Wollongong Local Planning Panel Assessment Report | 30 November 2021

WLPP No.	Item No. 1
DA No.	DA-2021/919
Proposal	Residential - demolition of dwelling house, construction of dual occupancy and Subdivision - Torrens title - two (2) lots
Property	13 O'Brien Street BULLI
Applicant	Kibbin Design Studio
Responsible Team	Development Assessment and Certification - City Centre Major Development Team
Development cost	\$1,220,000
Lodgement date	17 August 2021
Prior WLPP meeting	N/A

ASSESSMENT REPORT AND RECOMMENDATION

Figure 6: Extract from elevation plans showing extent of non-complying wall height

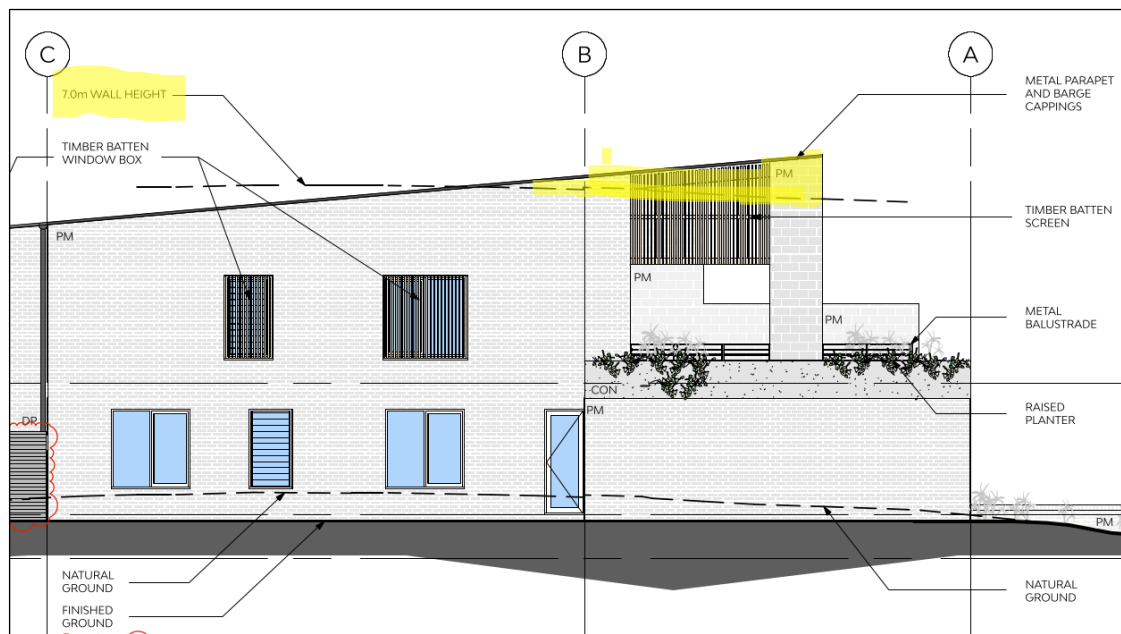
- The highest point of the dwellings is 8.7m. The max wall height permitted at 3m or less to boundary is 7m. This is a variation of up to 1.7m which extends for an approximately distance of 14m as shown on the western building elevation plan. The encroachment over this height limit is largely attributed to providing a double garage and the irregular lot shape that narrows from the front to the rear

of wall being in excess of 7m is not considered significant and results in no additional impacts in terms of overshadowing or visual impact as compared to a complying wall height. The applicant has provided sufficient information in support of the variation.

Having regard to the above, the proposed variation is considered acceptable and is supported.

NORTH ELEVATION

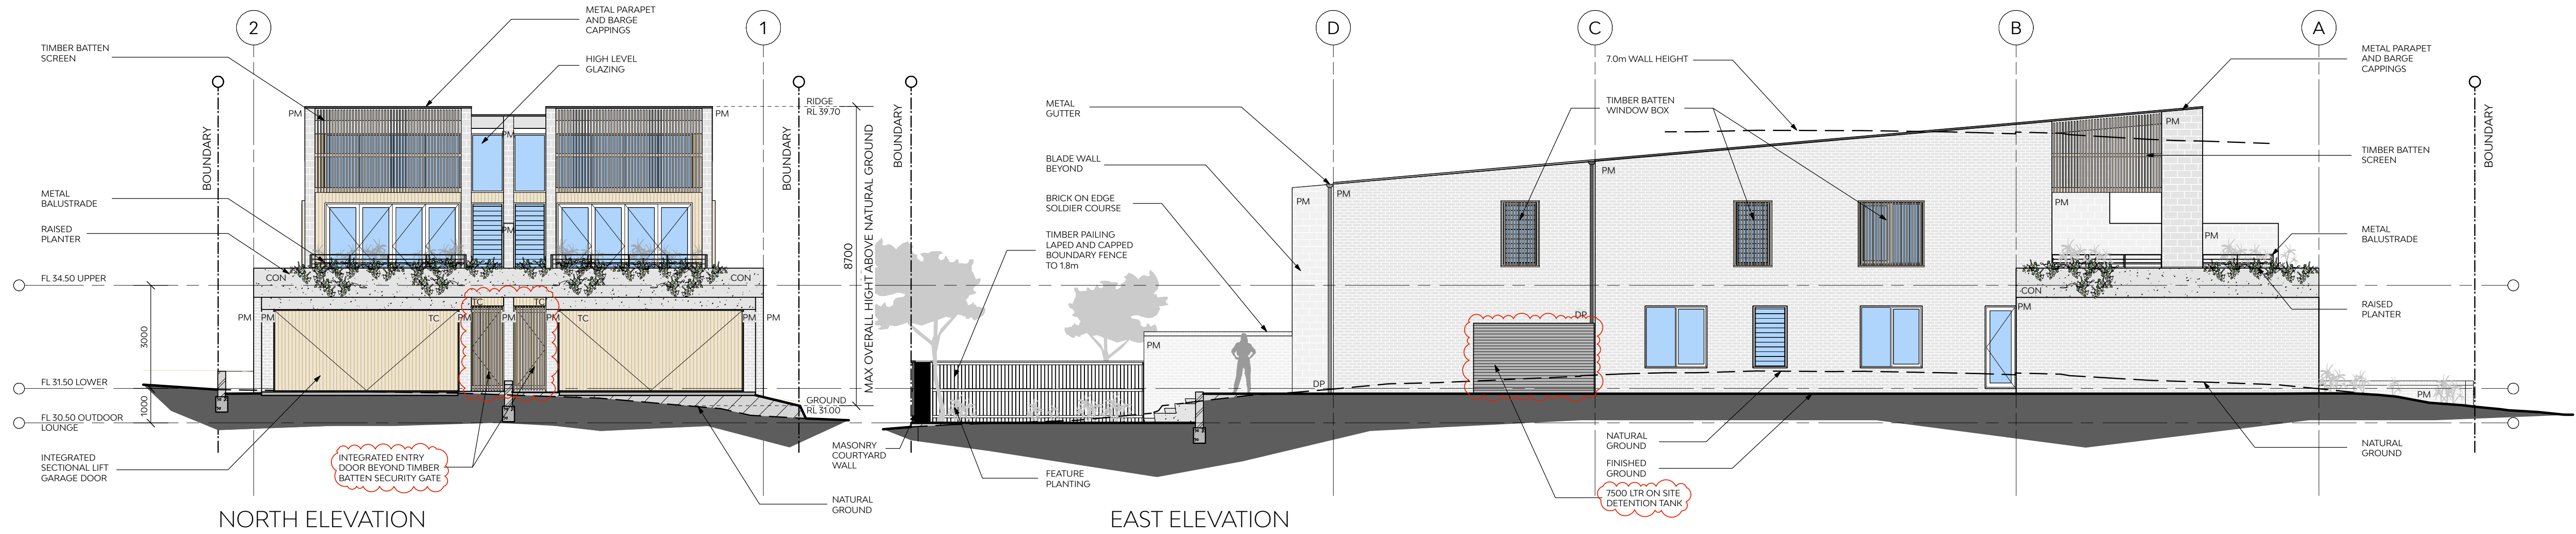
The garage dominance issue is evident when viewed front on as shown in Figure 4. Clause 4.10.2.4 of Chapter 1 of WDCP 2009 state that where garage door openings face a road they shall be a maximum of 50% of the width of the dwelling.

Notwithstanding the total width of the garage doors (10.8m which is 62% of the site frontage and 73% of the width of the building), the upper floor plan is set well back from the ground floor and this assists in alleviating the visual bulk of the building. The upper level maintains a 1.49m setback from side boundaries and this increases to 2.52m at the rear. These setbacks exceed the minimum 900mm setback. Further, the revised plan has reduced the extent of driveway to allow for an on street car parking space to be retained between the two driveways.
